Department of Transportation

MEMORANDUM

SUBJECT: BZA Case No. 21103 – 71 Kennedy Street NW

Figure 2. | Applicant Auto-Turn

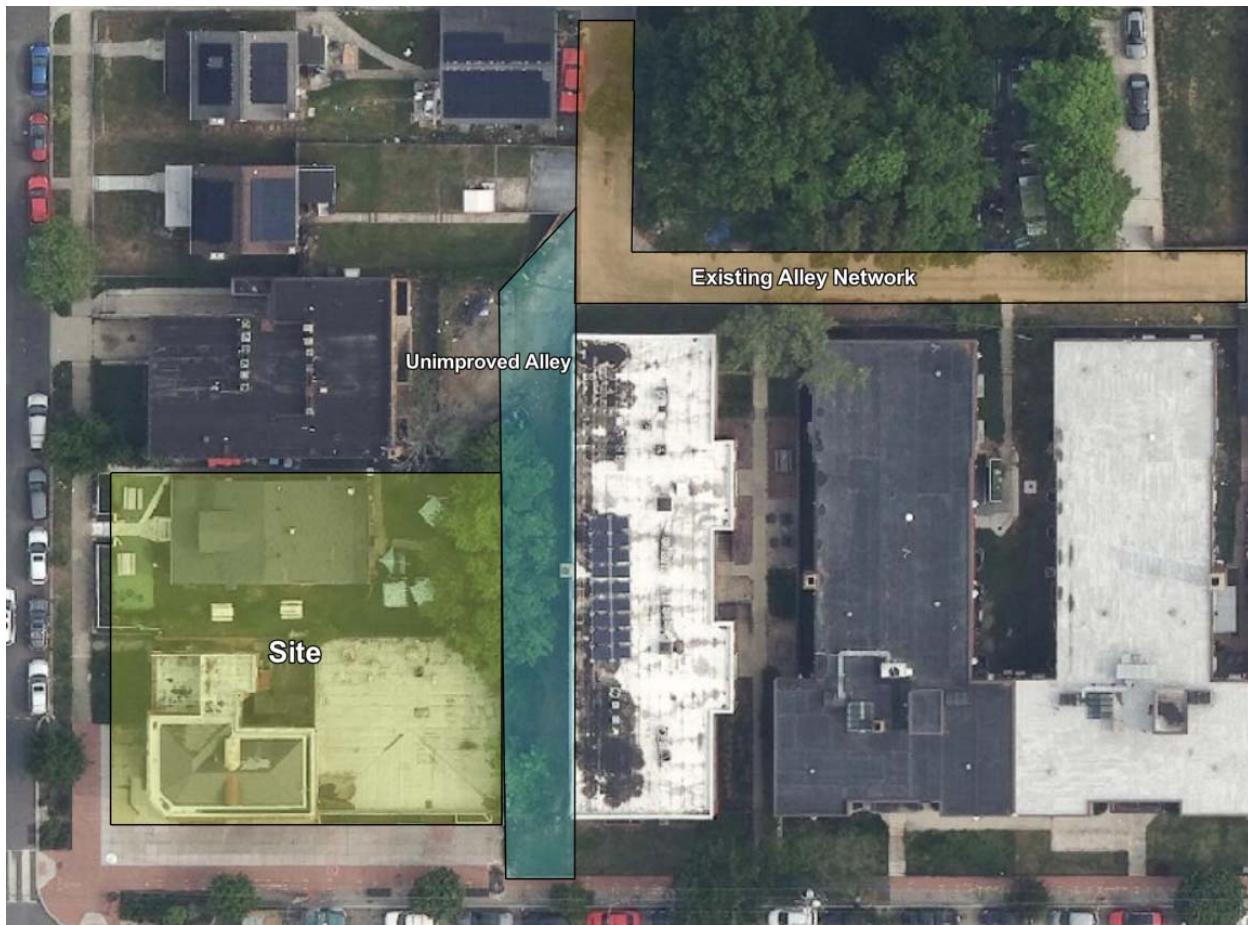
The Applicant is proposing to construct the full 15-foot paper alley extending from Kennedy Street NW to the larger alley network which has access points on Longfellow Street NW. Figure 2 shows the project site, paper alley, and existing alley network, which is not currently reflected on any of the BZA exhibits. DDOT supports the use and construction of the paper alley, which is the preferred location for vehicle access, but notes there are existing grade and topography challenges that require a more robust design review process. Given the grade challenges, the Applicant has agreed to enter into a Horizontal Public Use Agreement (HPUA) with DDOT outlining the design review, construction, inspection, and acceptance of the alley. The construction of the paper alley is a critical piece of the project and without the HPUA, the project may need redesigned or require further relief to accommodate vehicle parking on-site.

- The Applicant must enter into a signed Horizontal Public Use Agreement (HPUA) with DDOT outlining the process for design review, construction, inspection, and acceptance of the alley.

Figure 3. | Applicant Auto-Turn

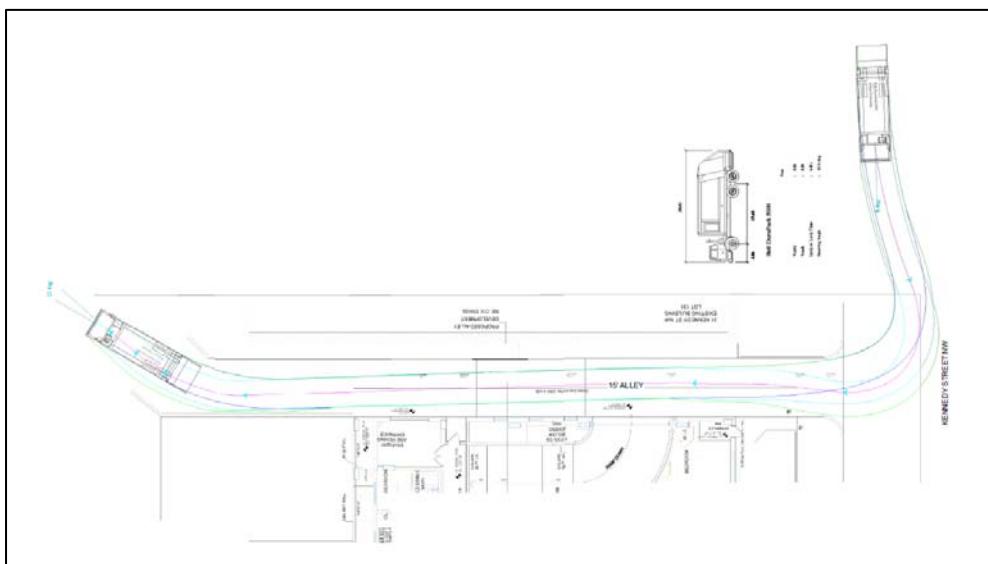
units, the Applicant must contract a private trash collection service. Trash must be stored entirely on private property, out of the view of the sidewalk, and collected via the improved alley connection. The Applicant has indicated that trash trucks will collect trash from the improved alley and continue into the larger alley network, shown in Figure 3. DDOT finds the proposed trash operations appropriate and finds the construction of the alley critical for trash operations.
